### ADDENDUM NO. 1 – September 14, 2021

### Manuel Valverde Park Shelter Improvements CIP PK 22-08

# ATTACHMENT A - Shade Shelter General Requirements

# 1. Shelter Column Pier Base Detail

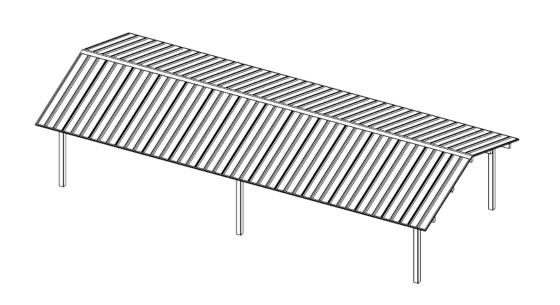
- 2. Delete EXPERIENCE OF BIDDERS, page 5 in Section 100 *Instructions to Bidders* of the Contract Specifications.
- 3. See Attachment "A", <u>Shade Shelter General Requirements</u> for shade shelter dimensions and column pier details.
- 4. Contractor shall purchase and supply both shade shelters.
- 5. Replace the second paragraph of 2. General Scope of Project and Work, page 1 in Section 500 *Sample Contract* of the Contract Specifications with the following:
